SYSTEM CONCEPT DEFINITION REPORT
for the
NATIONAL MAGLEV INITIATIVE

RESPONSES TO C.O.E. COMMENTS
SUPPLEMENT A: BACKUP MATERIALS FOR MAGWAY
FOUNDATIONS
SUPPLEMENT B: BACKUP MATERIALS FOR COSTS

RESPONSES TO C.O.E. COMMENTS

PROJECT MAGLEV - Magneplane System Concept Definition, CN 5-85

Phasor diagram.

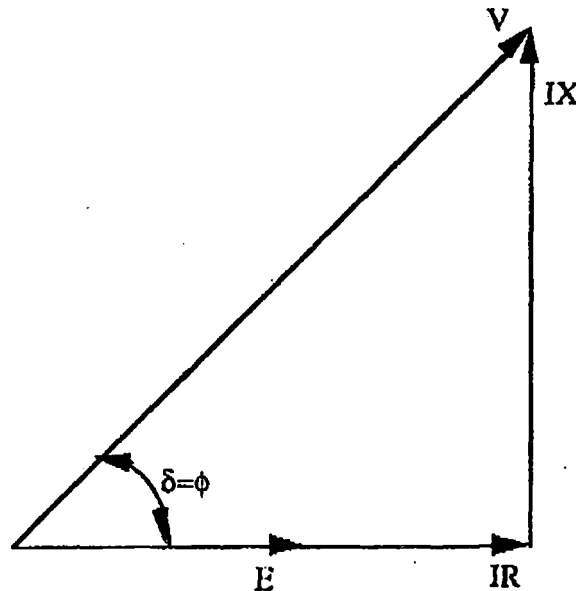
The operation point selected for the linear synchronous motor does not seem reasonable because the power factor is too low. On page 217, the author stated that the LSM will produce peak thrust and no levitation force when $\alpha=0$. Indeed, it is true there is no levitation force when $\alpha=0$. However, the peak thrust does not occur at $\alpha=0$. The analysis is as follows:

When E and V are kept constant, there is maximum power at $\delta = 90$ degree. Now let's verify that $\alpha=0$ does not correspond with the peak power output.

Another comment is that choosing $\alpha=0$ as operating point is not good because the power factor is very poor at that point. The contractors considered that at $\alpha=0$, there is no reactive power output so that they thought that the operation point is optimal. For a general rotating motor, it is okay. However for a LSM, the inductance is usually large, especially if a two-km block length is selected. That inductance X will yield lagging reactive power so that the overall power factor is only 0.26. Hence, an operation point with a leading reactive power should be selected to compensate the lagging reactive power (resulting from the long block length) when designing a LSM.
